Service Information

Built-in Oven

AKPM 759/IX

Service Bulletin 4812 715 40401

TITLE: Improved oven shelf grid design

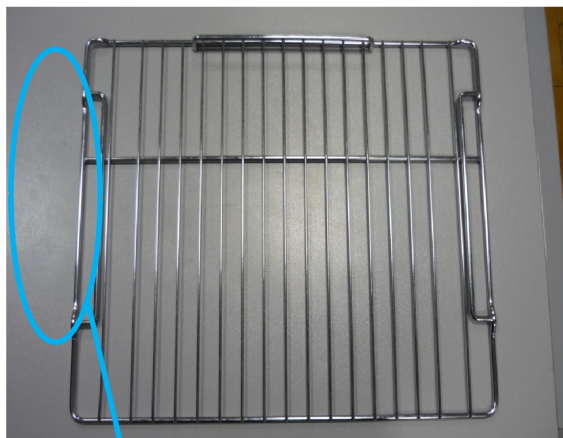
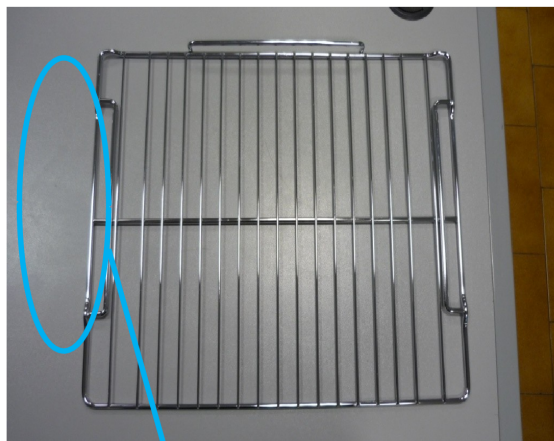
SUBJECT: Stability issues with oven shelf grid

The mechanical design of the oven shelf grid has been modified for solving the stability issue.
The oven shelf grid 4801 211 01183 has been substituted by 4810 105 18218.

Old code: **4801 211 01183**New code: **4810 105 18218**

Wire has been moved toward the back in order to have more stability when grid is inserted on lateral grids and sliding shelves

TITLE: Spring used to fix the thermostat on the back of the cavity

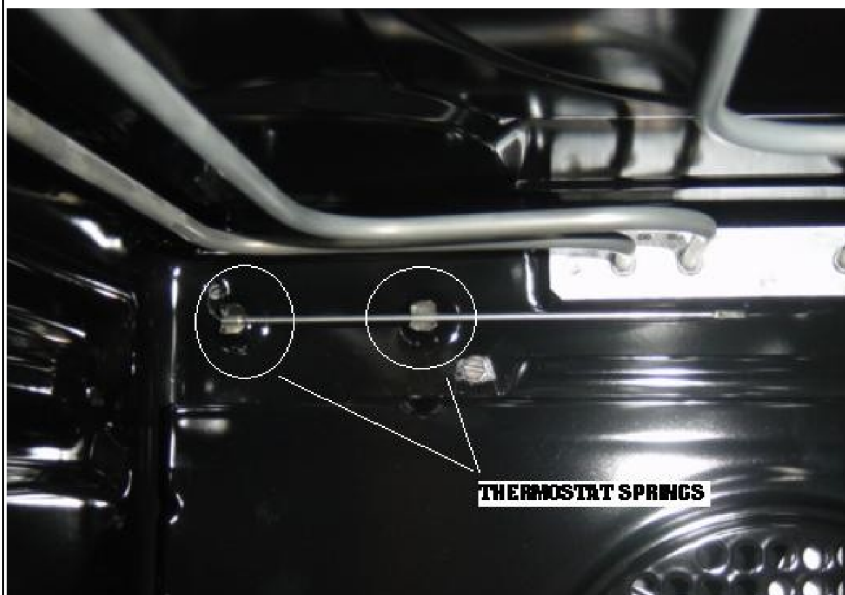
If part breaks or is lost

The metal clamp to fix the thermostat inside the cavity is from now on listed in the parts lists. To your information here the part number:

Exchange with spare part

4812 404 18649

Metal spring to fix the temperature feeler.
